Advisory Action Attachment

112 FIRST PARAGRAPH

Art Unit: 1791

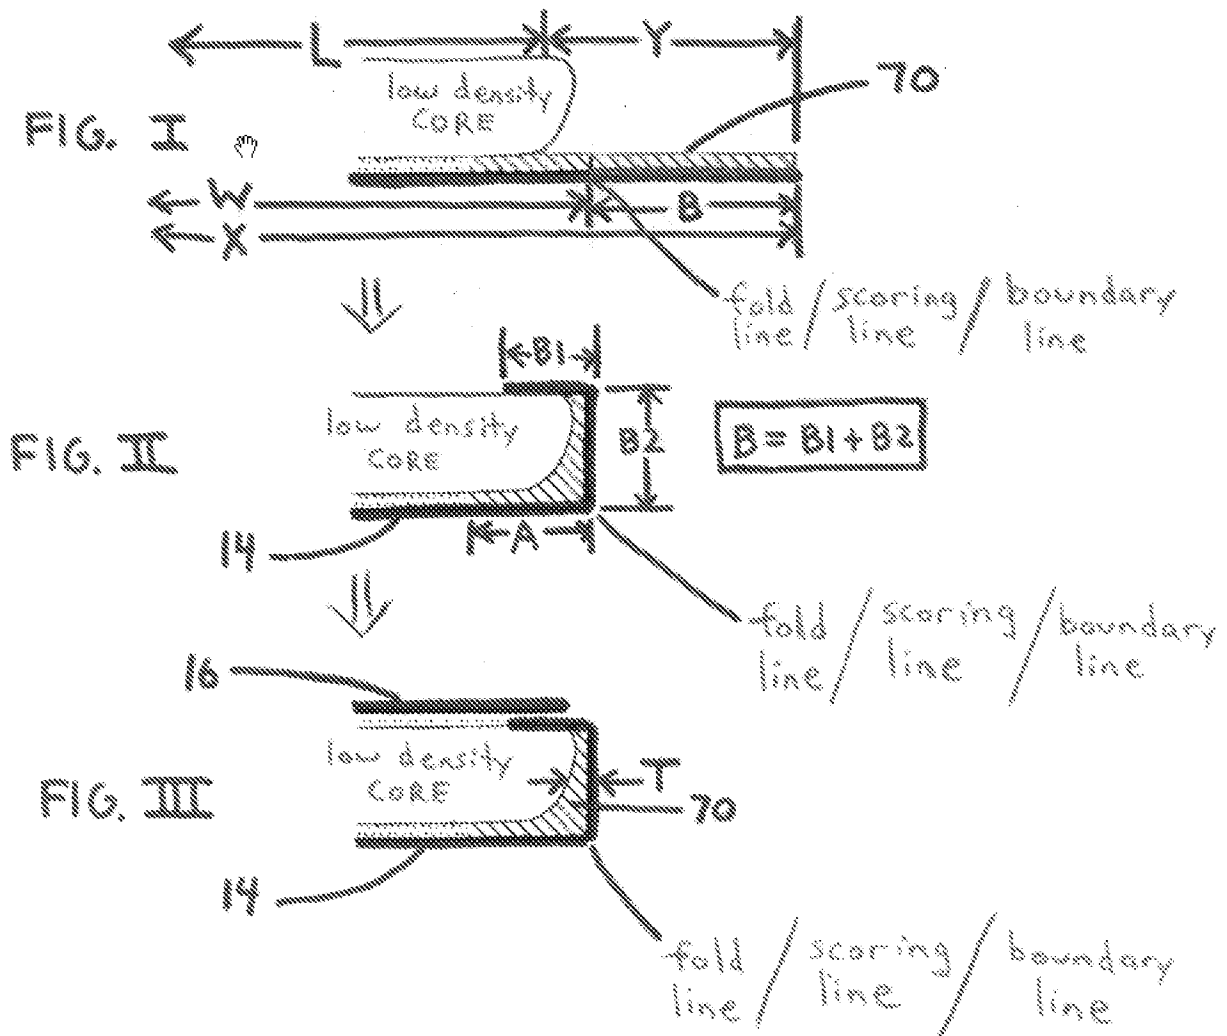
Figure I, Figure II and Figure III (as presented above) were prepared by examiner using applicant's illustration of the L-SHAPE in Figure 5. The illustration shows three steps - (1) before folding of face paper 14 (Figure I), (2) after folding of face paper 14 (Figure II) and (3) after application of back paper 16 (Figure III). The reference characters have the following meaning:

In above Figure I, the high density slurry 70 was drawn by examiner as extending to the edge of the paper because Figure 2 of applicant's disclosure appears to illustrate the high density slurry as extending to the edge of the face paper 14. The boundary line between distance L (length of spreading roller 22) and distance Y (length of the non-spread portion) is indicated as being inside of the fold line / scoring line because Figure 2 appears to illustrate the spreading roller as having a length less than the distance between the fold lines defined by folding shoes 61.

Applicant argues and examiner agrees that the width of the non-spread portion is different from the width of the board. As can be seen from above Figure 1, **width W of the board is greater than width Y of the non-spread portion.**

Applicant argues and examiner agrees that the slurry for the non-spread portion may flow. As can be seen from a comparison of above Figure I and above Figure II, the high density slurry 70 for the non spread portion flows to form the hard edge part when the face paper 14 is folded.

Applicant argues that the length of the hard edge part may be more than the width of the non-spread portion. Examiner disagrees. From a cursory inspection of above Figure I and above Figure III, it can be seen that **length T of the hard edge part is less than width Y of the non-spread portion.** Examiner asserts that the *folding of the face paper and the flow of the high density slurry prevent length T of the hard edge part from being longer than width Y of the non-spread portion.* Thus, examiner maintains that the combination of the range of 0.1 mm to 15 mm for the length of the hard edge part (the broad disclosure) and the range of less than 10 mm for the width of the non-spread part (the preferred disclosure) is not supported by the original disclosure (i.e. the combination of these ranges is new matter). Claim 1 reads on the length (15 mm) of the hard edge part being greater than the width (less than 10 mm) of the non-spread part, and applicant failed to have possession of this subject matter at the time of filing of the original disclosure.

spread portion being "less than 10 mm". This argument is not persuasive. FIRST: The relevant standard for showing possession of the claimed invention is "reasonably convey" instead of "it is possible". SECOND: It is not possible for length T of the hard edge part to be more than width Y of the non-spread portion because the length of the hard edge part is limited by the folding of the front paper.
